## Upgraded Gearcase Offering - Verado L6 Models

Models Covered	Serial Number Or Year
200/225/250/275/300 with 4.8 Inch Gearcase Torpedo	1B831023 and Below

**a -** Recessed circle (port side) identification mark for new gearcase with 5.44 inch torpedo

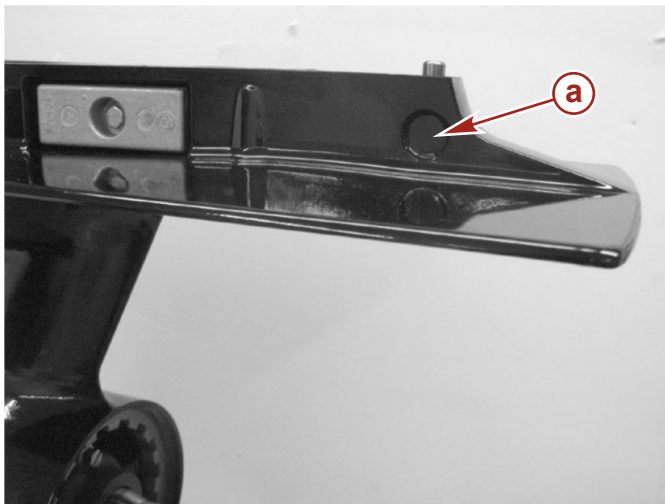
With the introduction of the new 5.44 inch Verado gearcase, Mercury Marine can provide its customers with an improved gearcase for world-class reliability, durability, corrosion resistance, performance, and versatility in all waters of the world. Mercury Marine would like to offer the new gearcase as an upgrade to our qualifying customers as follows.

Should a Verado standard gearcase (4.8 inch torpedo) experience a warrantable failure on a single outboard, heavy boat (7 meters [23 feet] or longer), Mercury Marine will replace the gearcase with the new 5.44 inch gearcase.

When servicing a warrantable 4.8 inch gearcase failure on a multiple outboard Verado boat package, Mercury Marine will replace the failed gearcase with the new 5.44 inch gearcase and upgrade the remaining serviceable gearcases on the boat to the new gearcase to maintain a matching set. These gearcases will be provided at no charge to qualifying customers.

## Shift Shaft Alignment for 5.44 Inch Verado Gearcase Installation

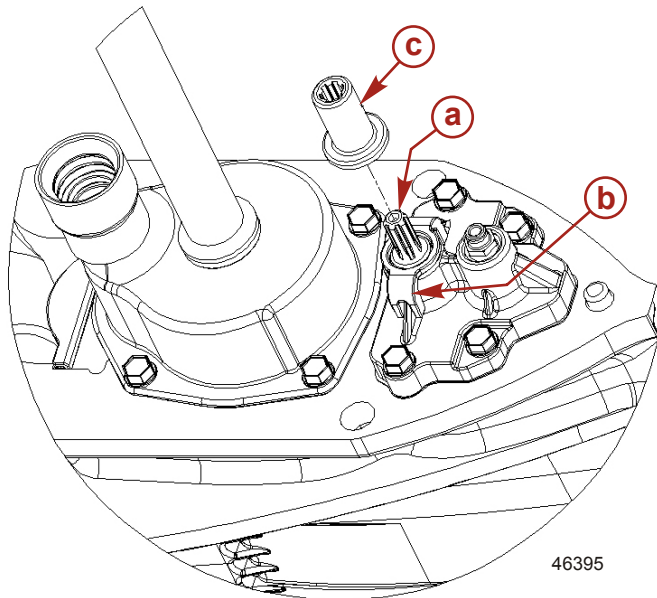
**IMPORTANT:** The 5.44 inch Verado gearcase is not equipped with a neutral detent. Use this information to supplement the current Verado service manual for gearcase installation.

1. While rotating the propeller shaft in either direction, turn the shift shaft counterclockwise to engage the sliding clutch fully into the gear. Note the position of the shift shaft.
2. Turn the shift shaft clockwise to allow the propeller shaft to turn freely. While rotating the propeller shaft, turn the shift shaft clockwise fully into gear. Note the position of the shift shaft.
3. Rotate the shift shaft counterclockwise to the center location of the noted gear engagements. This is the neutral position.
4. Rotate the propeller shaft to verify the neutral position. The propeller shaft will rotate freely in either direction.
5. Install the shift shaft retainer assembly.
6. Install the coupling onto the shift shaft.
